SERVICE BULLETIN

Classification: EC97-050	Reference: NTB98-024	Date: March 15, 1998
-----------------------------	-------------------------	-------------------------

DIAGNOSTIC PROCEDURE FOR DTCs P0120, P0510, P0731, P0732 OR P0733 WITH NO DRIVEABILITY INCIDENTS

Figure 1

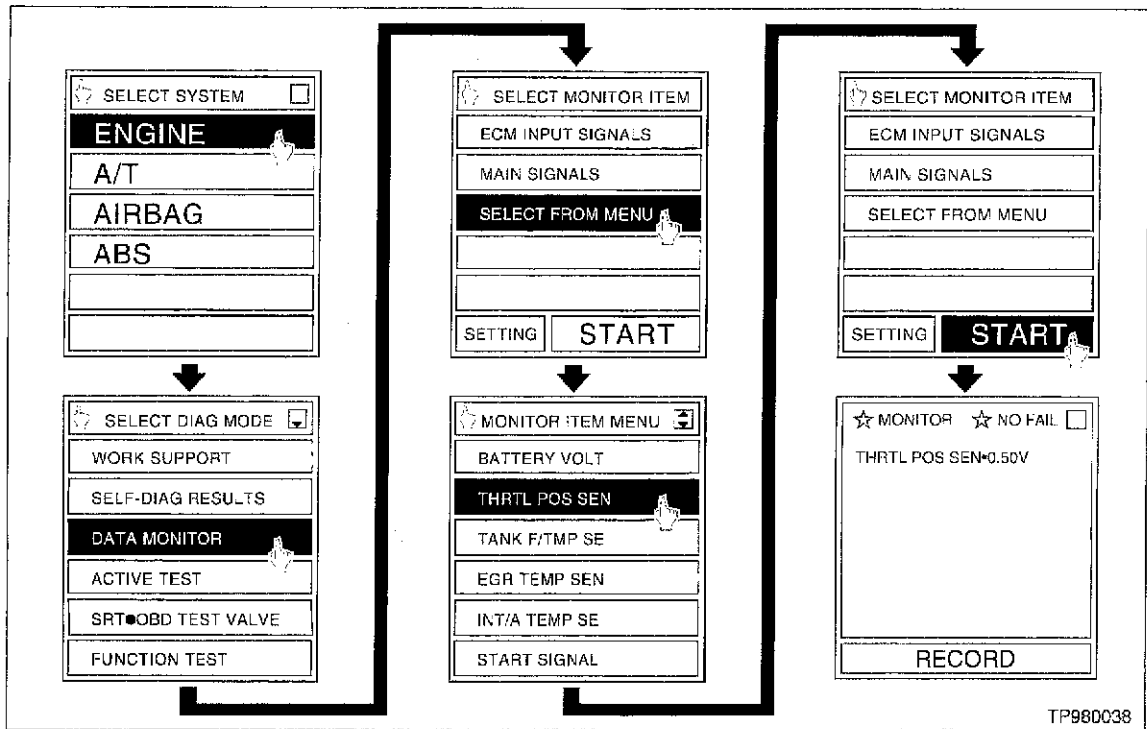
1. Start the vehicle and warm up the engine (coolant temperature above 160°F).
2. Shut the engine off. Then turn the key to the ON position.
3. Using CONSULT, select THRTL POS SEN in the Data Monitor mode (see Figure 1, page 2).
4. Note the TPS voltage (initial resting voltage).
5. Depress the accelerator fully and then release slowly until it releases completely.
6. Wait 5 seconds and monitor the TPS voltage again (final resting voltage). Note any change.

- A) If the final resting voltage is greater than the initial resting voltage, proceed to step 7.
- B) If there is no measurable difference between the initial and final resting voltages, refer to the specific DTC code diagnostic procedure in the appropriate service manual.

Figure 2

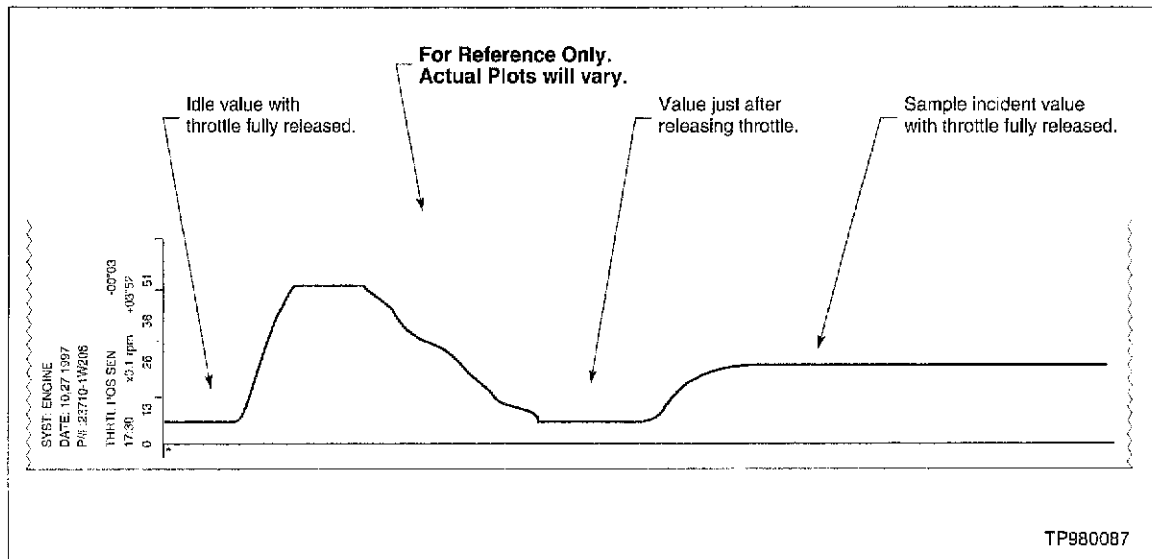
NOTE: Figure 2 is a visual representation of the incident and is **for reference only**. It will be easier to perform this test based on the actual voltage values displayed (as in Figure 1) rather than to graph the voltage output. *Use the actual voltage values to calculate the change.*
